Amendments to the Drawings:

OAI REPLY.DOC
PMAI/00-108
July 23, 2003

Fig. 15

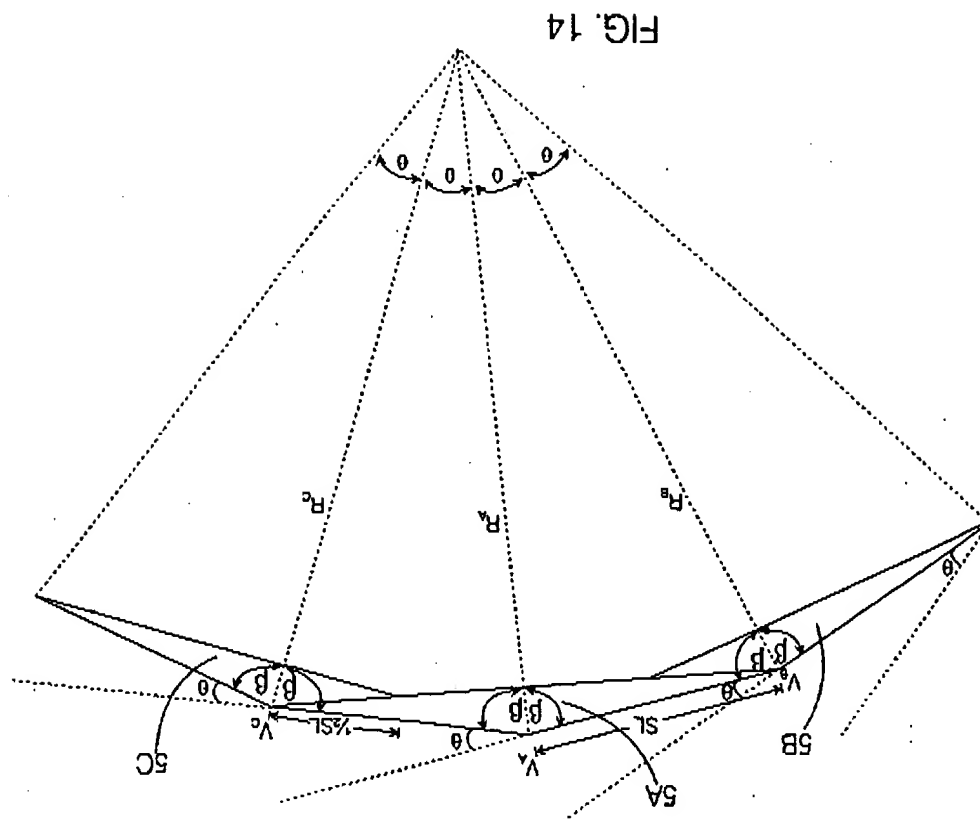
New FIGS. 14, 15 and 16 are added. FIG. 14 is an illustration of overlapping hub elements 5, showing in greater detail the information shown in FIGS. 4 and 5. FIGS. 15 and 16 illustrate embodiments that were discussed in the Specification as filed, but not illustrated. Informal drawings are attached hereto.
